## CITY OF GLENDALE, CA

### DESIGN REVIEW STAFF REPORT – SINGLE FAMILY

<b>April 18, 2024</b> <i>Decision Date</i>	<b>1239 Rossmoyne Avenue, CA 91207</b> <i>Address</i>
<b>Historic Preservation Commission</b> <i>Review Type</i>	<b>5646-002-008</b> <i>APN</i>
<b>PDR-003119-2024</b> <i>Case Number</i>	<b>Edgar Markosyan, ArcSTEM Inc.</b> <i>Applicant</i>
<b>Eric Ji</b> <i>Case Planner</i>	<b>Ani Malkhasyan</b> <i>Owner</i>

The applicant is proposing a two-story addition at the rear façade and the enclosure of a balcony at the front façade. A total of 489 square feet (SF) will be added to the first floor and 599 SF at the second floor. The two-story single family house was built in 1927 and contains 2,413 SF. The 10,920 SF lot is zoned R1-HD (Floor Area District II). The project also includes a 377 SF addition to the existing detached two-car garage, a new detached covered patio, and a 62 SF detached accessory building. The property is identified as a contributor to the Rossmoyne Historic District.

2 SITE PLAN (N)  
1/8" = 1'-0"

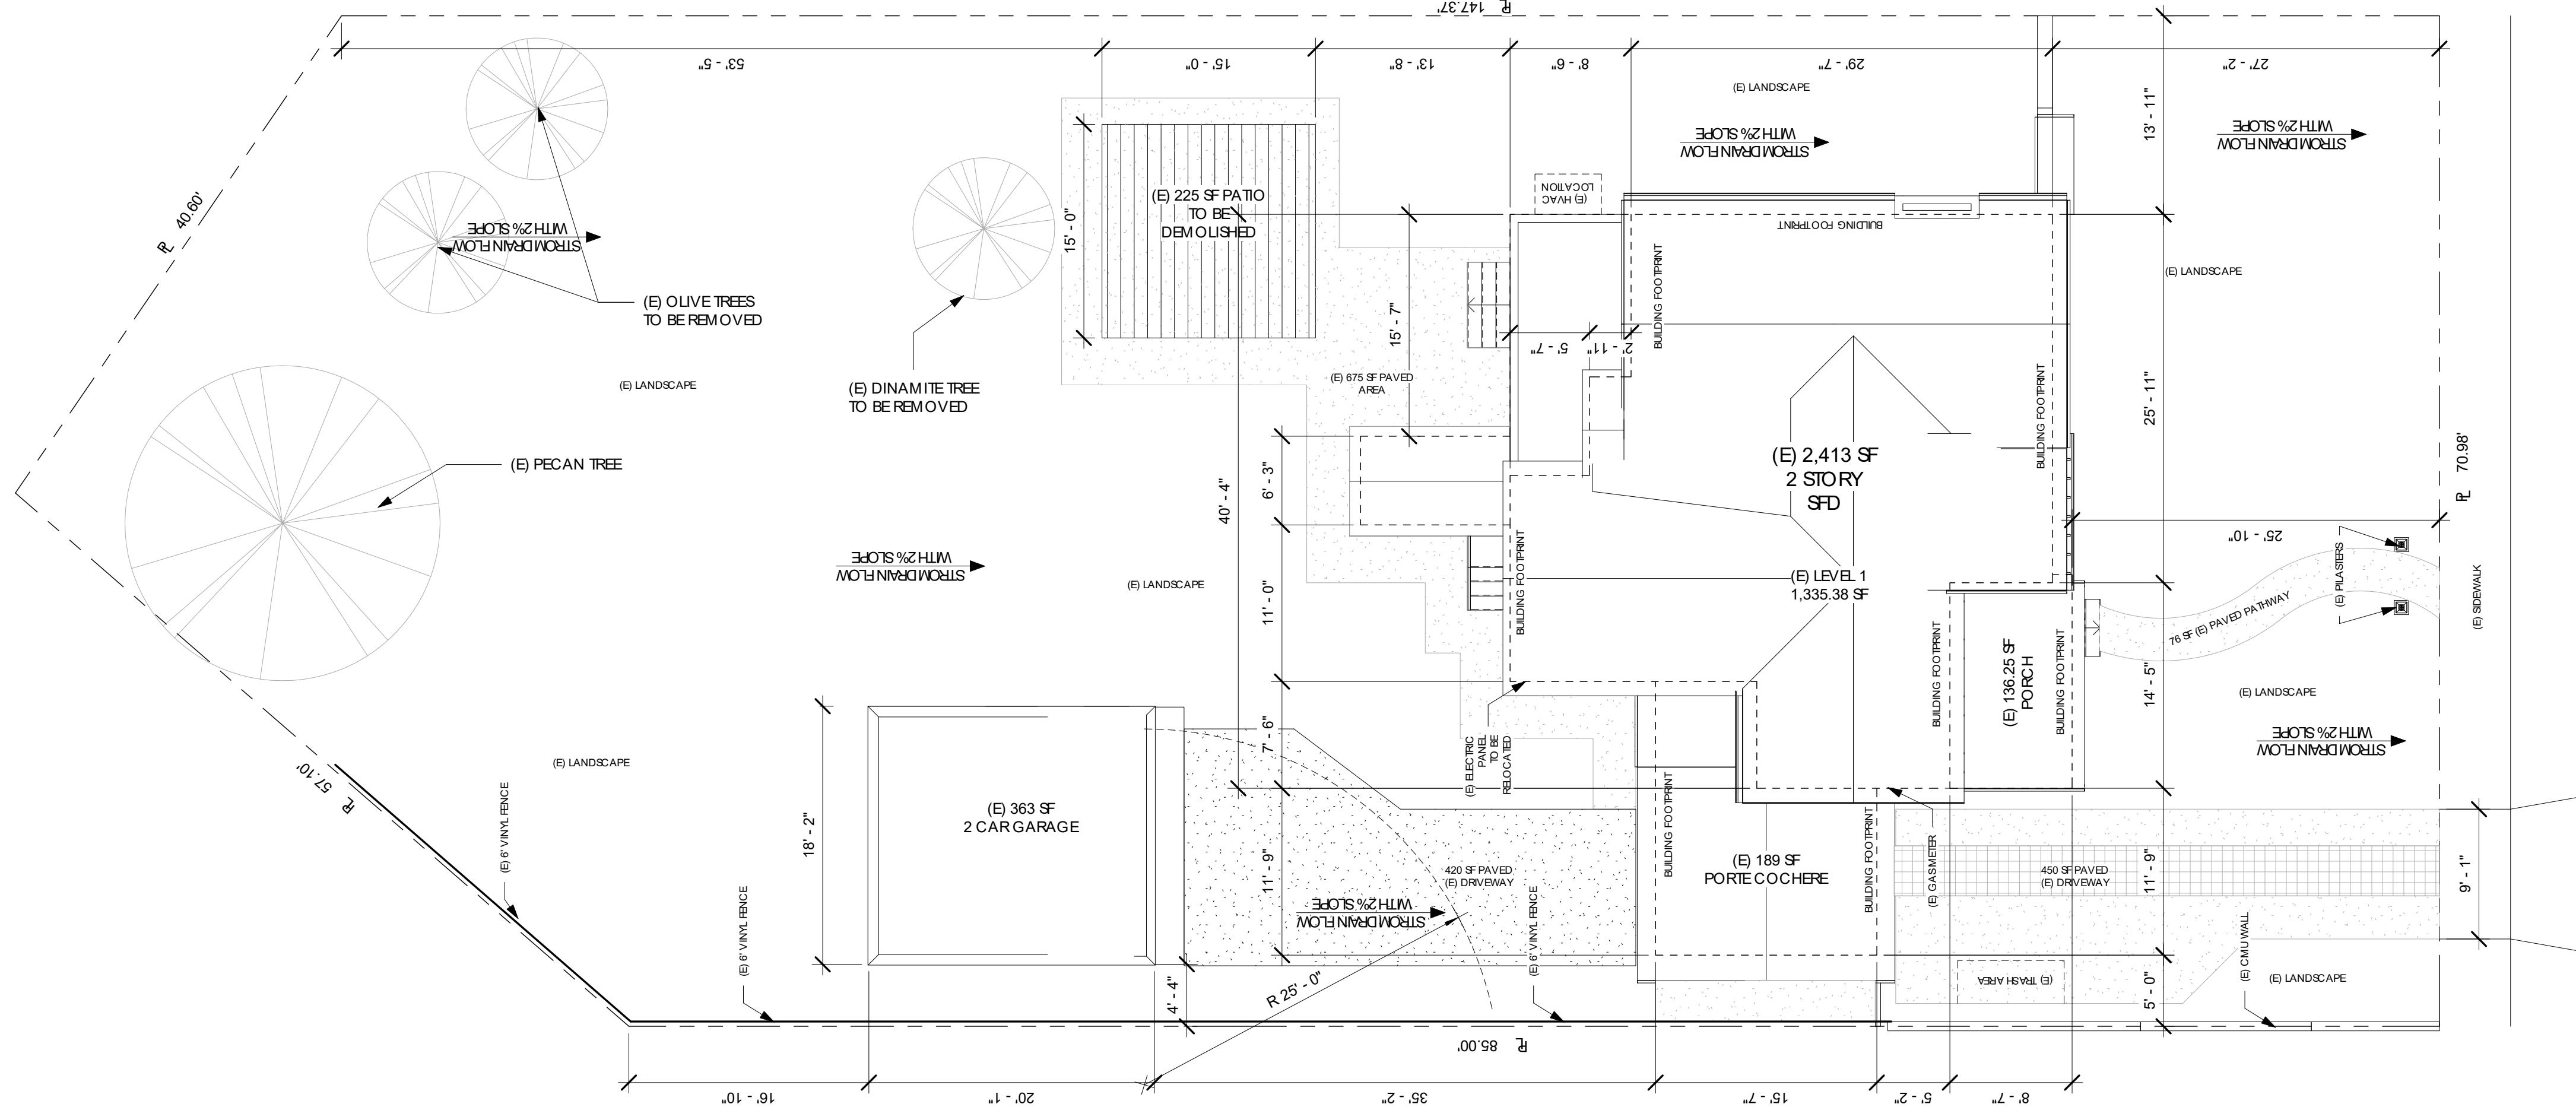
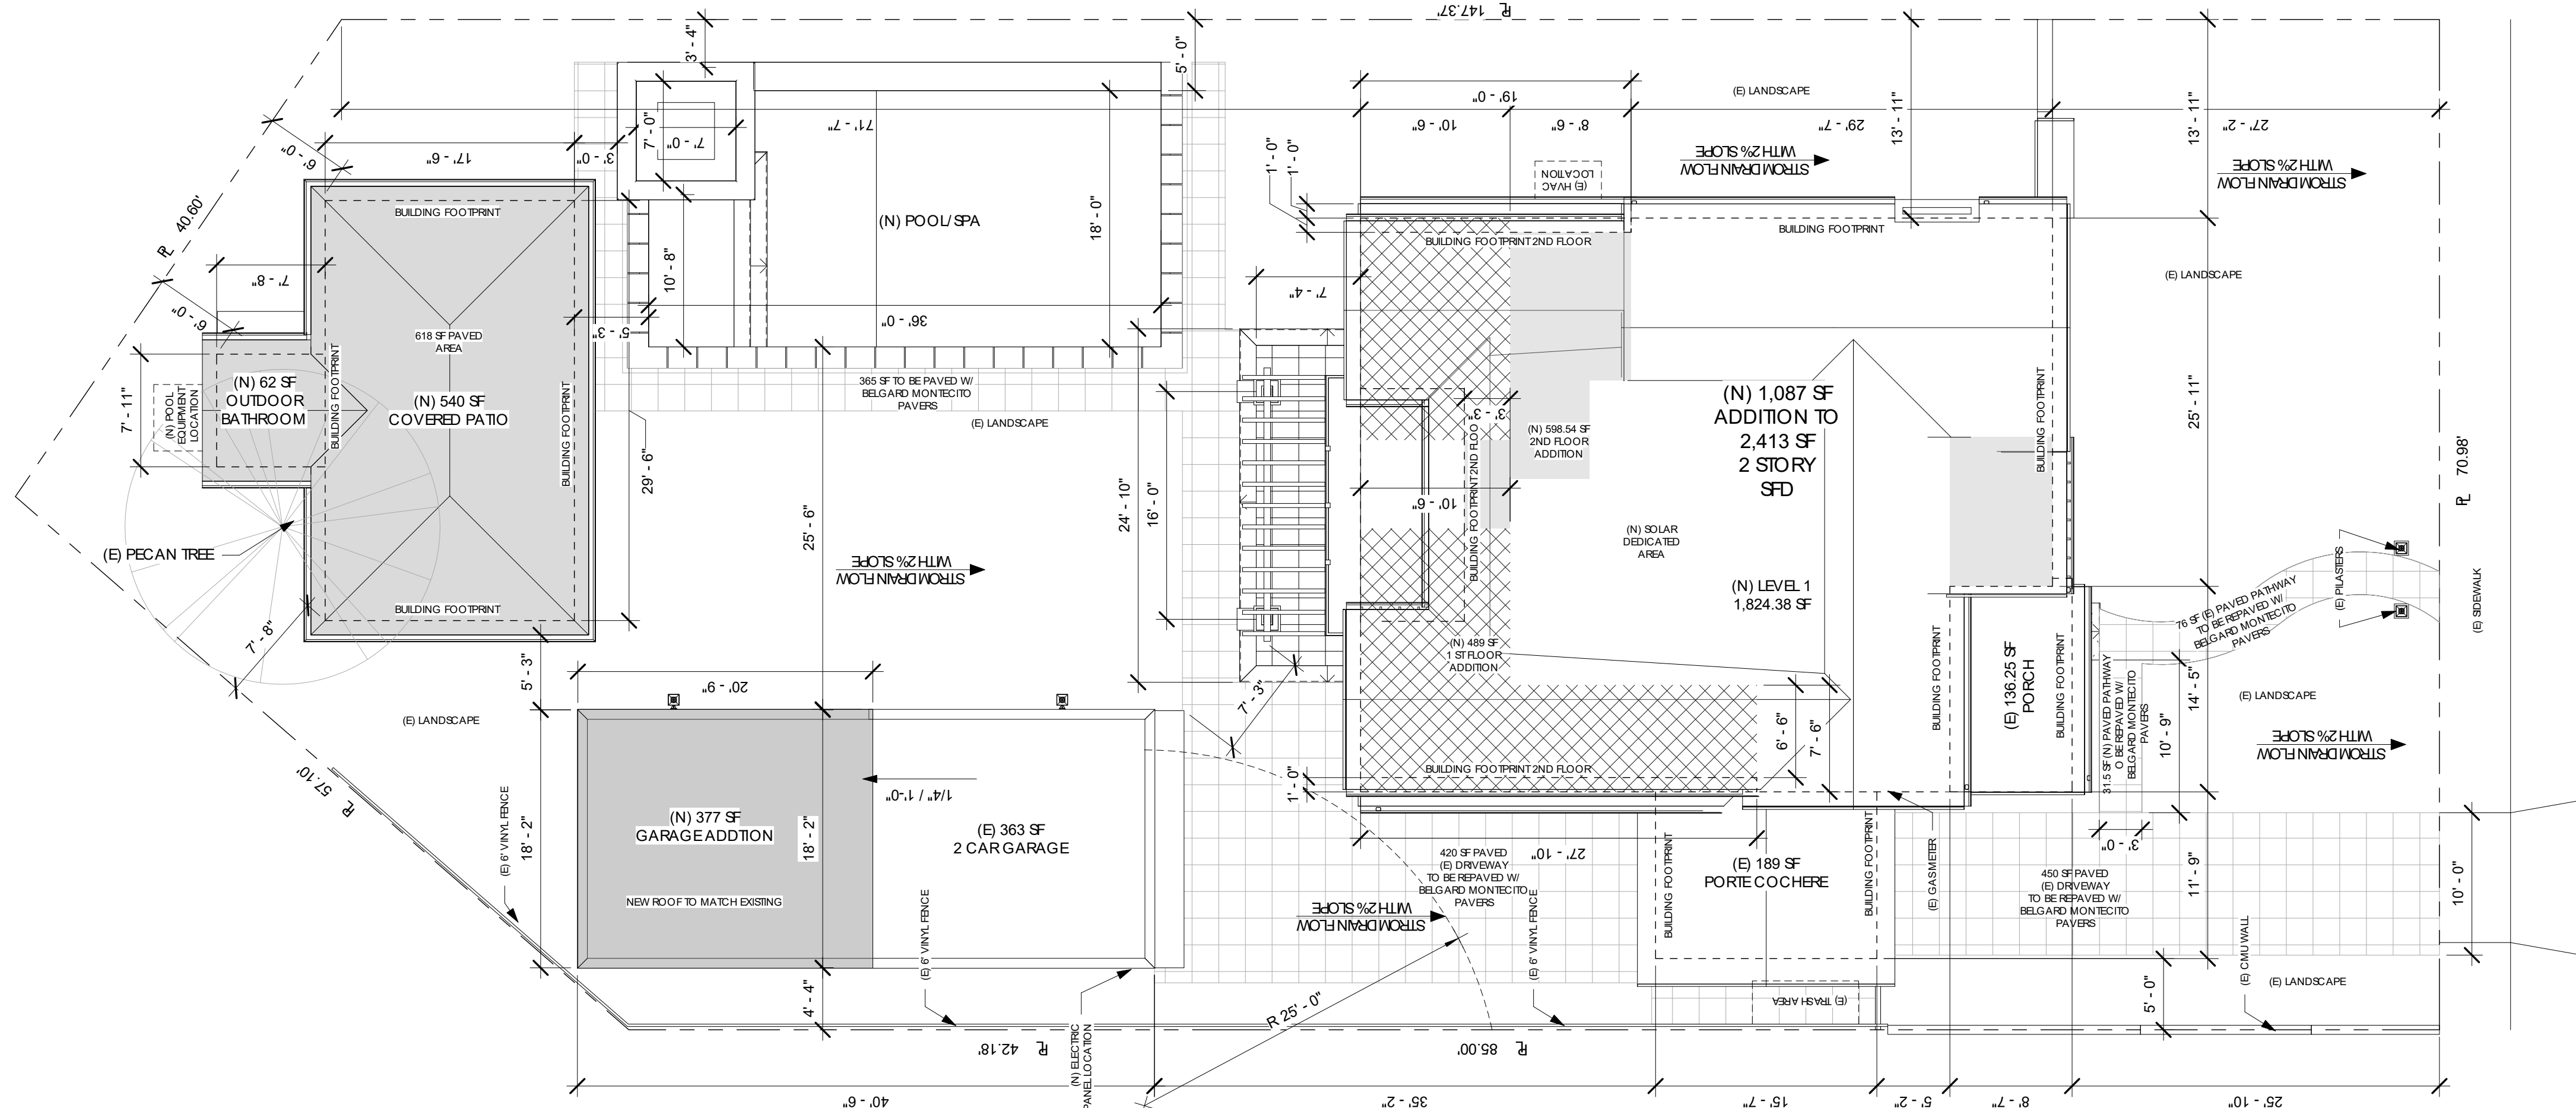
The pavers for the driveway and front walkway are not appropriate to the style and period of the house. The existing “Hollywood” driveway is damaged but should be either repaired or replaced in kind to maintain the early appearance of the house.

As noted above, the proposed pavers at the driveway and front walkway are not appropriate.

1. The enclosure of the second-floor balcony and removal of the existing decorative vents should be omitted from the proposal.
2. The proposed driveway and front walkway pavers are not appropriate to the style and period of the house. The damaged “Hollywood” driveway should be either repaired or replaced in kind. The existing front walkway is not original but can be retained due to its unobtrusive visual character.
3. Provide additional information, including dimensioned drawings of the existing windows for staff verification regarding the closeness of their appearance. The Commission may also consider requiring that the wood windows at the front façade and side facades that are closer to the street be retained, and that the new windows be limited to the addition and less visible portions of the side facades.
